Office Action Summary	Application No. 10/663,554	Applicant(s) BERRY, BRET M.	
	Examiner JAMES L. SWIGER III	Art Unit 3775

DETAILED ACTION

**FIG. 3**

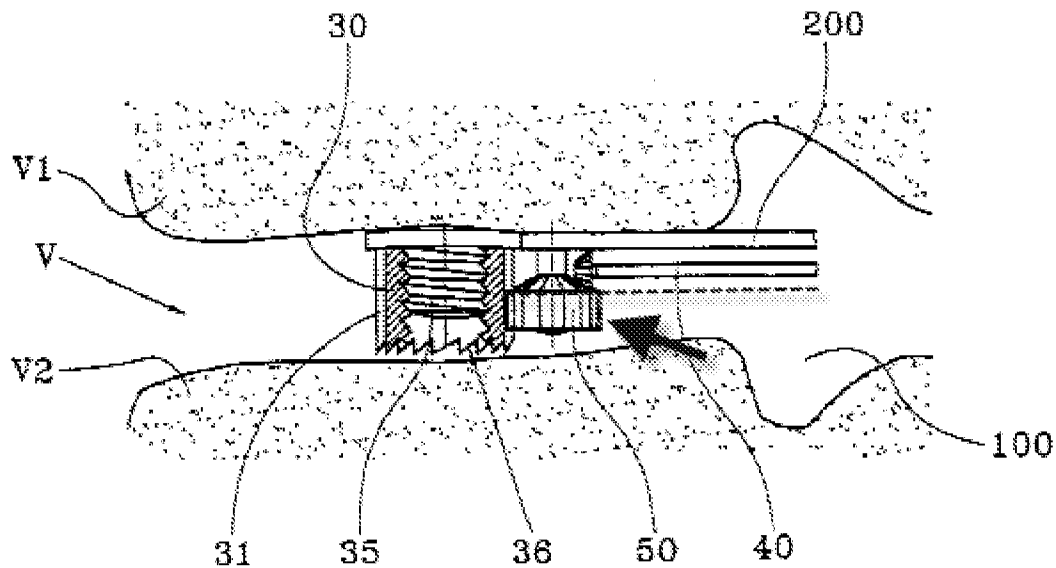
Claims 23-24 and 27-29 are rejected under 35 U.S.C. 102(e) as being anticipated by Zacuto (US Patent 6,692,495). Zacuto discloses an axle (40) defining a first axis and having a proximal end (towards the gear end, Fig. 3) and a distal end (opposite) and wherein the axle is adapted to rotate about the first axis, a first gear and

a second gear (50, Fig. 3) connected to the axle and also wherein a first gear is adapted to rotate about the first axis, and wherein the gears are attached to the proximal end of the axle. A second gear rotates about a second axis (axis shown in Fig. 3). See below.

It is noted that the top portion of 50 shown above is considered the second gear and the second bottom portion (arrow) is considered an engager device with a toothed section. This engager device is fixedly secured to the gear and has conjoint rotation therewith about a second axis. Fig. 4 shows a top view with teeth or cog-shaped projections that extend outwards and that are capable of engaging an implant. These sections rotate the implant portion (30/35). Each end could be considered a plated portion and a threaded connection moves them relative, and further has an outer casing (200).
